TOWN OF VERNON
Inland Wetlands Commission (IWC)
Special Meeting Notice & Agenda
Tuesday, February 15, 2022, 7:00 PM

FROM: George K. McGregor, AICP, Town Planner

SUBJECT: IWC 2021-07, 57 Hartford Turnpike

PERMIT PLAN
LAND OF SUB PEAK OF CONNECTICUT, INC.

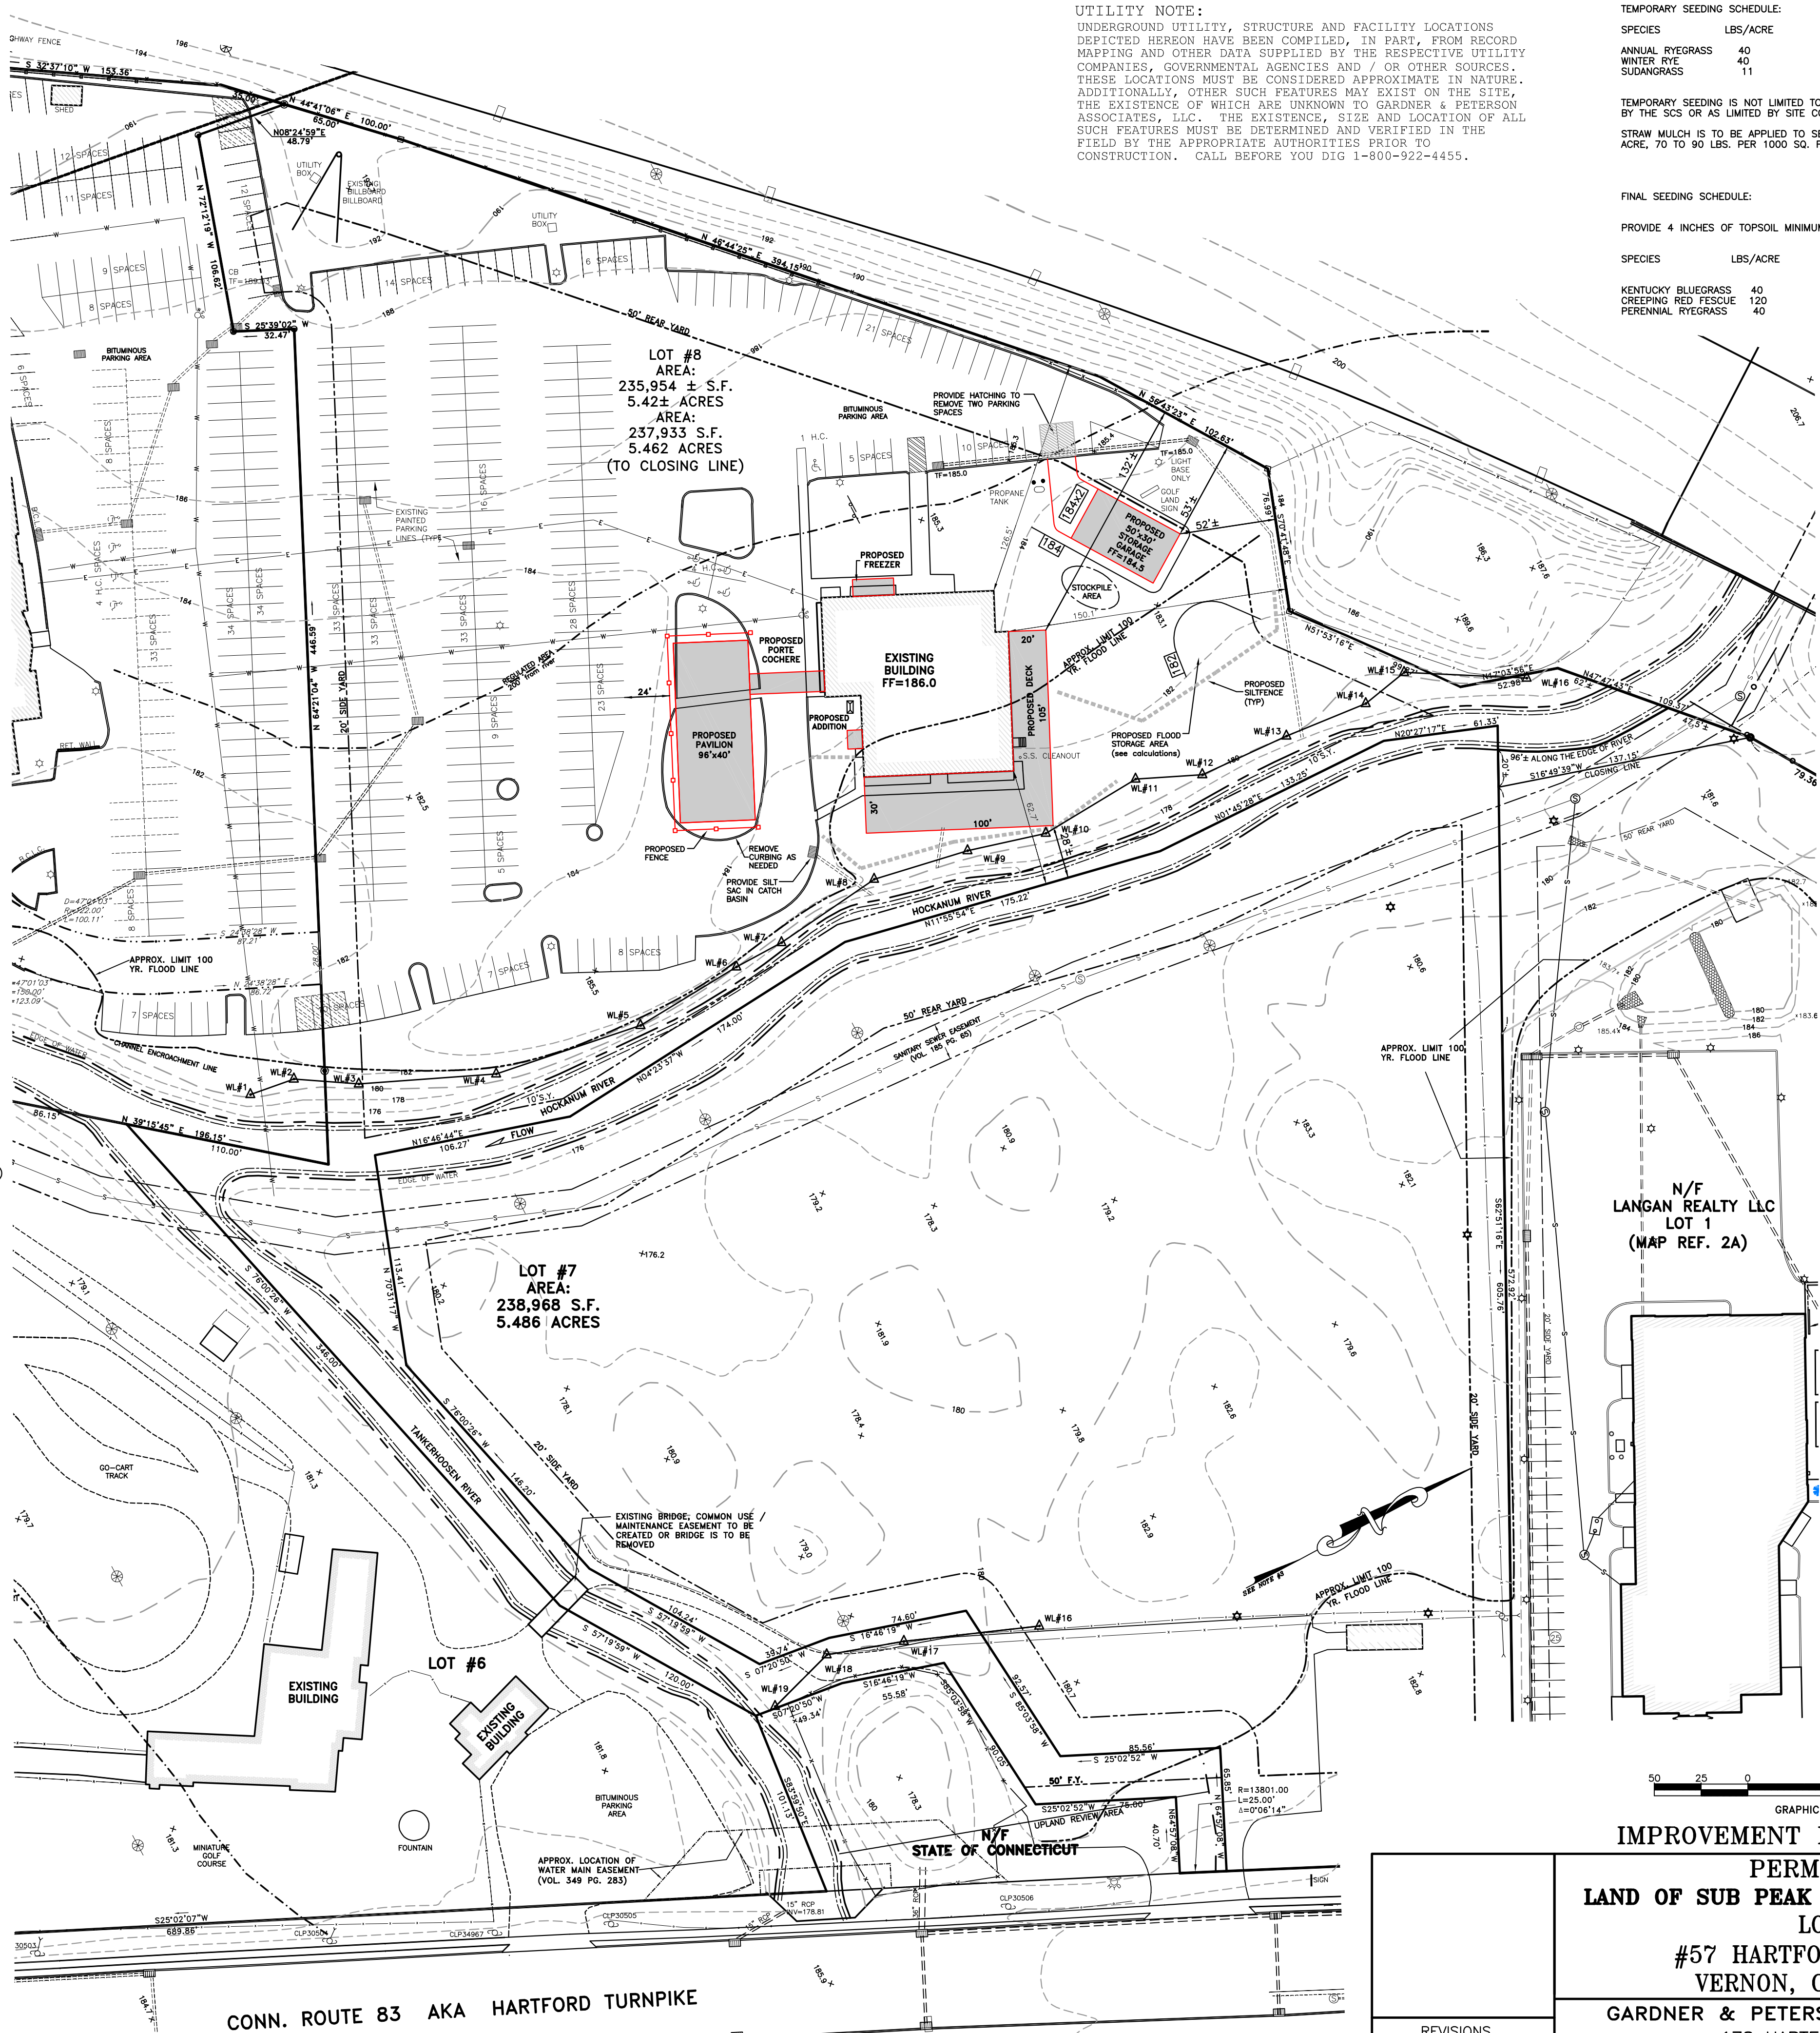
These improvements are intended to provide outdoor capabilities for a future restaurant. The deck is proposed right up to the edge of the newly designated wetland area, leaving little room between the deck and the wetland. Sensitive construction practices will help to reduce impacts on the wetland area. The applicant has shared the pile design with staff and it is included in the packet. This type of design appears to minimize impacts in the regulated area and on the adjacent wetlands.

The pavilion, attached to the entrance porte cochere, will have a concrete surface on the ground underneath, which is an increase in impervious surface. The garage addition will have little impact on the wetland area. Staff has asked the applicant to consider potential mitigation measures such as riparian plantings, tree islands in the parking lot, or other measures to counter the new development impacts.

If the size of the deck is reduced, there would be more room for landscaping / plantings that would help protect the watercourse.

AND, Subject to the Site Plan of Development dated December 10, 2021, prepared by Gardner & Peterson, Associates, LLC.

SITE PLAN OF DEVELOPMENT
CONNECTICUT GOLF LAND – PHASE II
#95 HARTFORD TURNPIKE
VERNON, CONNECTICUT

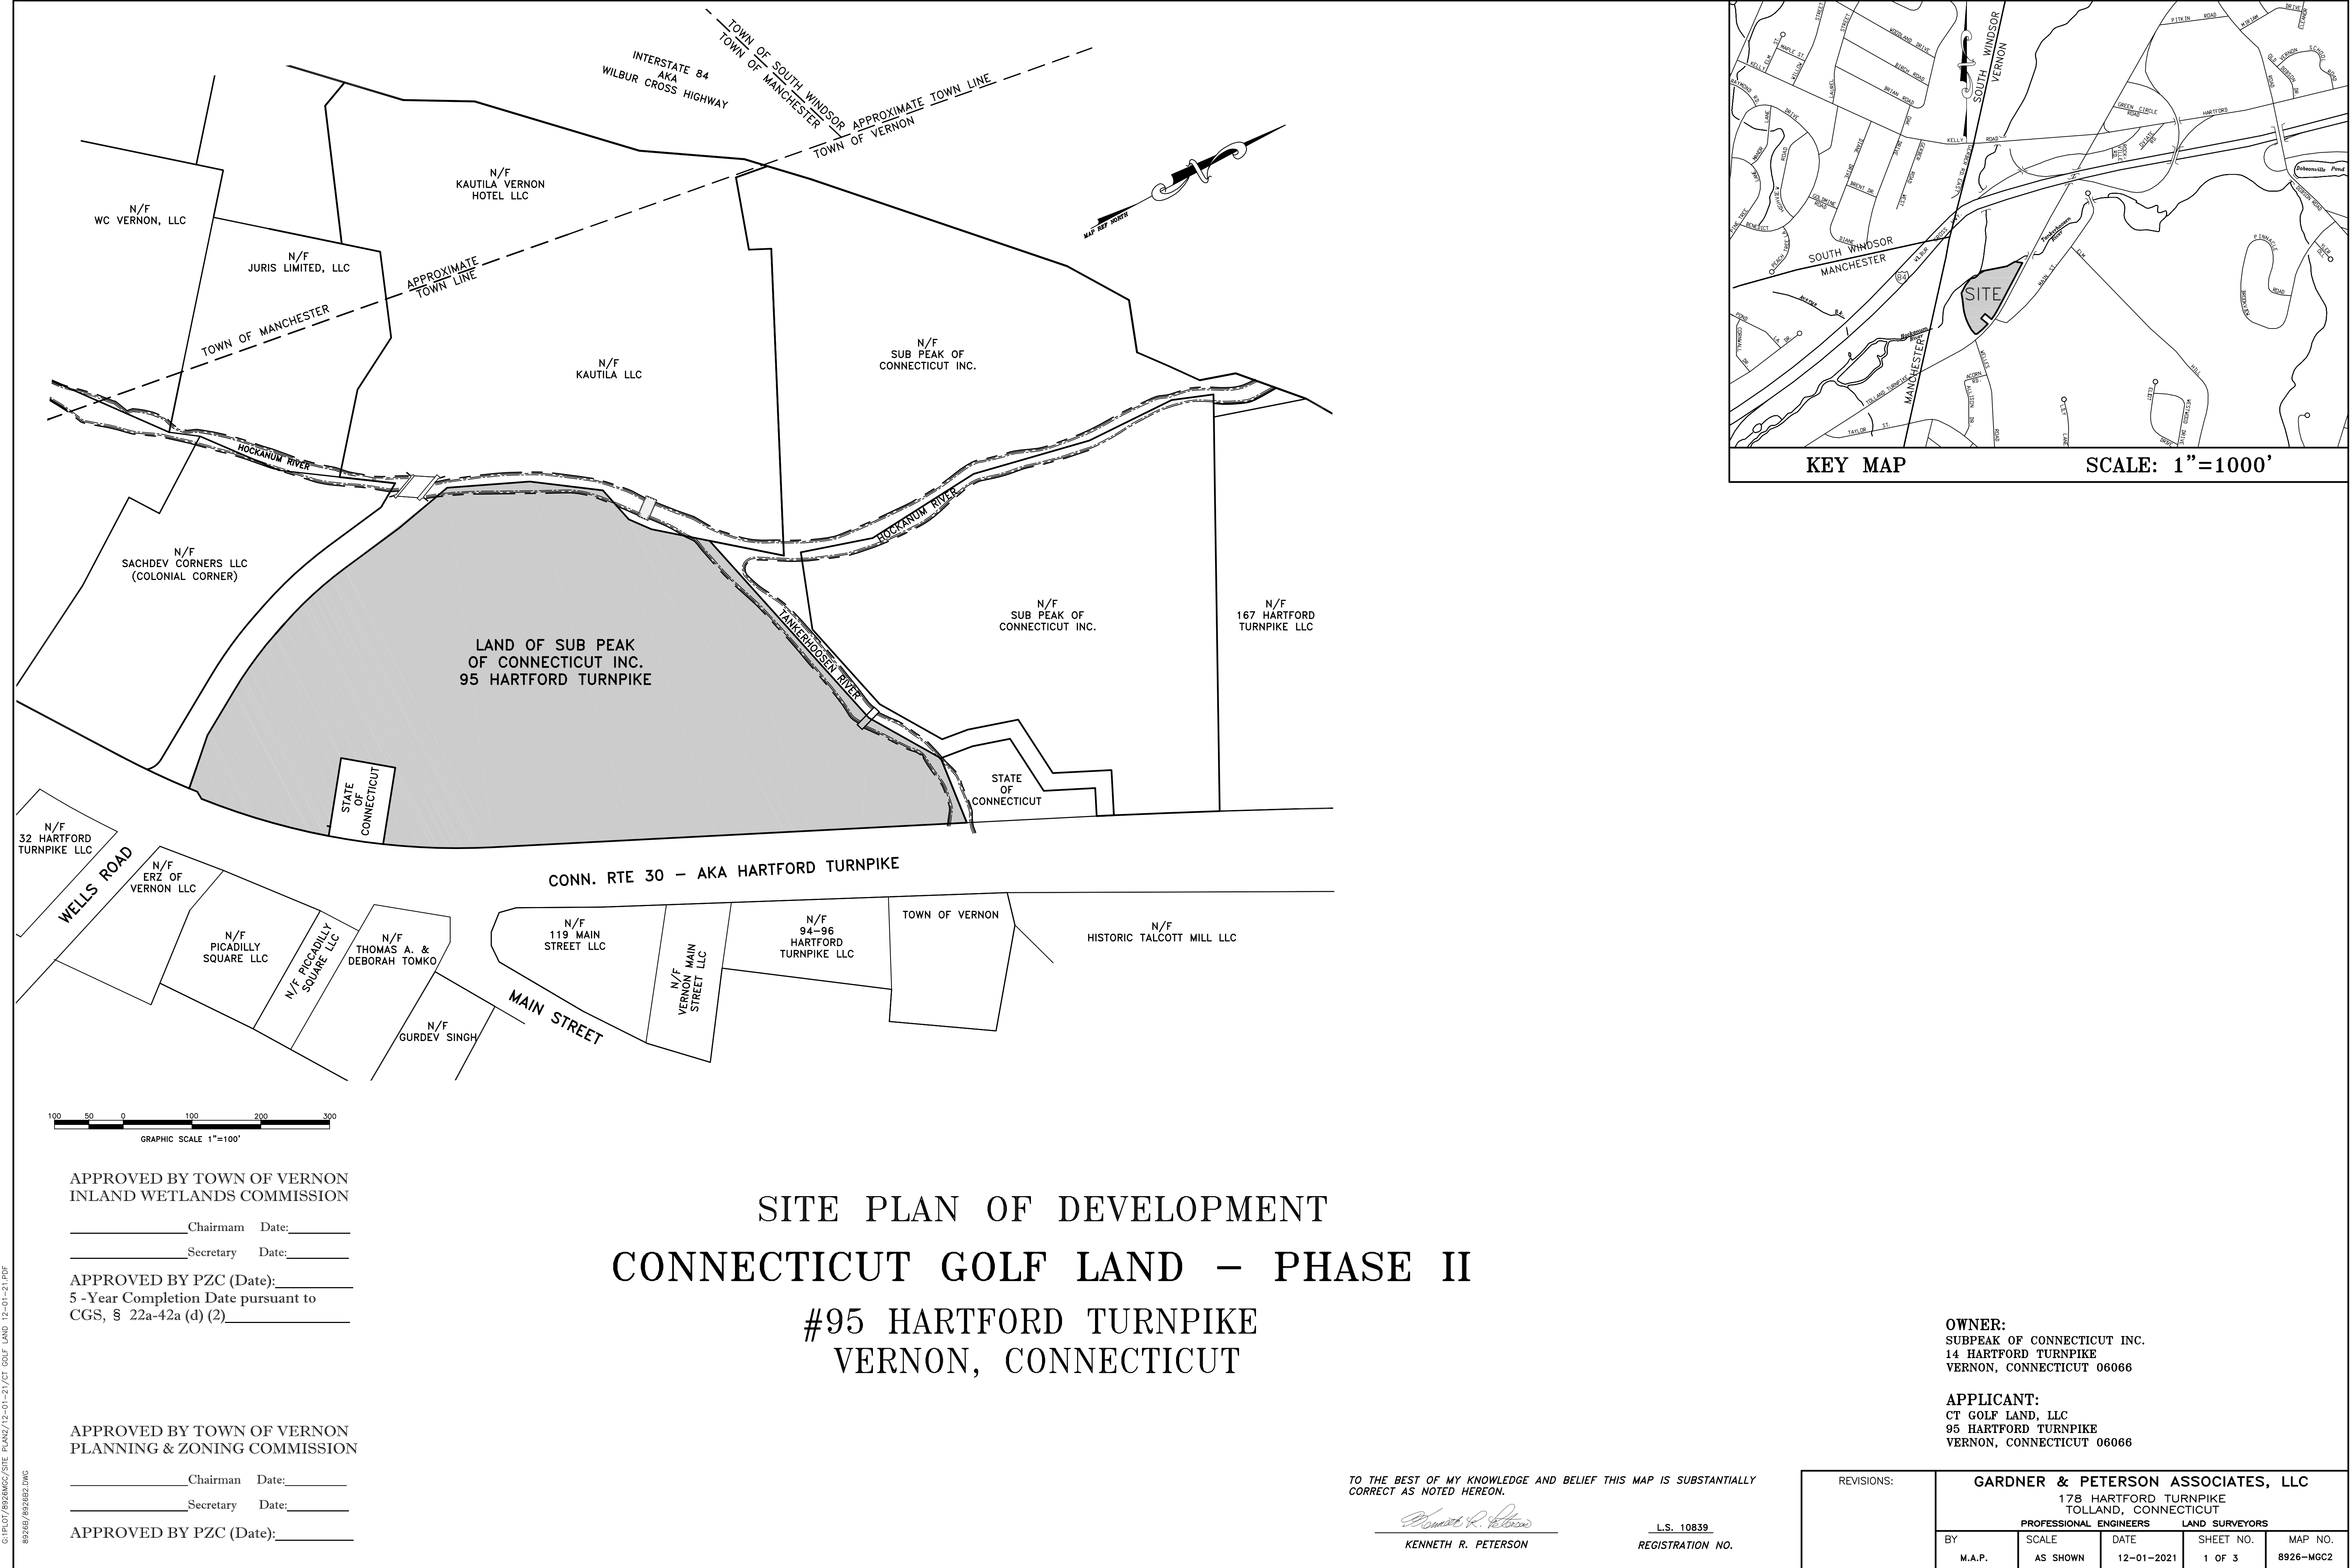
The proposed redevelopment of the Golf Land Site appears generally sensitive to the environmental features present (the site had previously been significantly disturbed during iterations of development on this site). The applicant has considered additional flood storage on site in an effort to improve those conditions. Although the total impervious surface was reduced by 12,900 sq. ft. according to the Phase I plans, Phase II adds back 16,000 sq. ft. for a net project impervious increase of approximately 3,000 sq.ft.

I have a couple concerns with these proposed phase II plans.

The proposed golf area does not show any proposed development within the shaded area.

AND, Subject to the Site Plan of Development dated December 1, 2021, prepared by Gardner & Peterson, Associates, LLC.
